TRANS/WP.29/793
2 August 2001

World Forum for Harmonization of Vehicle Regulations (WP.29)

DRAFT SUPPLEMENT 6 TO THE 09 SERIES OF AMENDMENTS
TO REGULATION No. 13

(Braking)

Figure 8: HYDRAULIC-TRANSMISSION BRAKING SYSTEM

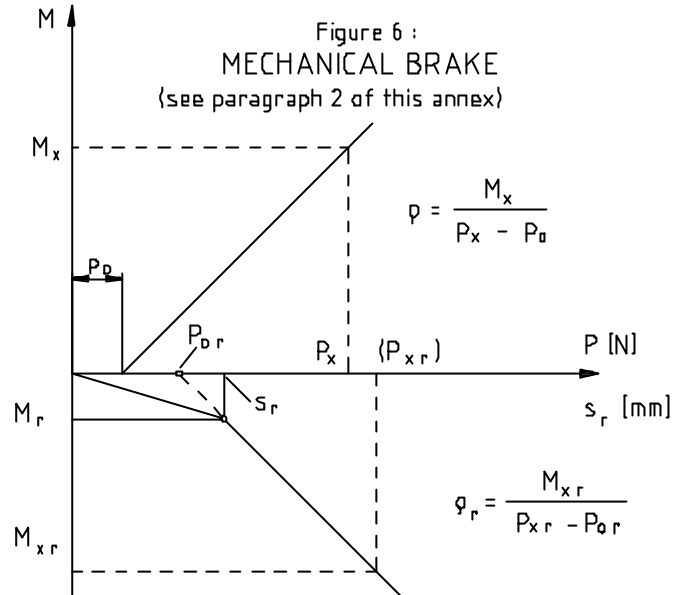
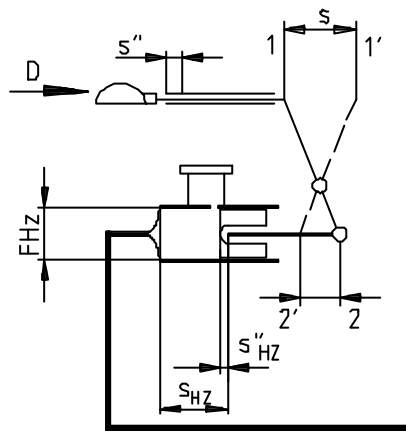
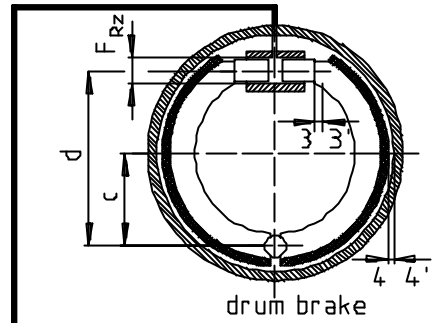
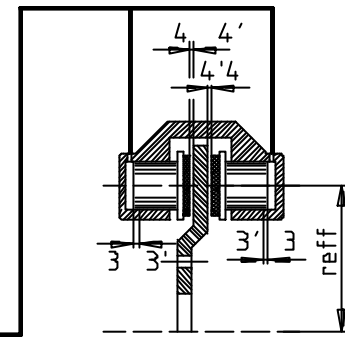
Annex 12, appendix 1, figures 6,7 and 8, amend to read:

$$i_h = \frac{1 - 1'}{2 - 2'}$$

$$i_g = \frac{d}{c} = \frac{3 - 3'}{4 - 4'}$$

$$i_g = \frac{r_{eff}}{r_{eff}} = \frac{3 - 3'}{4 - 4'} = 1$$

$$i_g = \frac{r_{eff}}{r_{eff}} = \frac{3 - 3'}{2 \cdot (4 - 4')} = 1$$
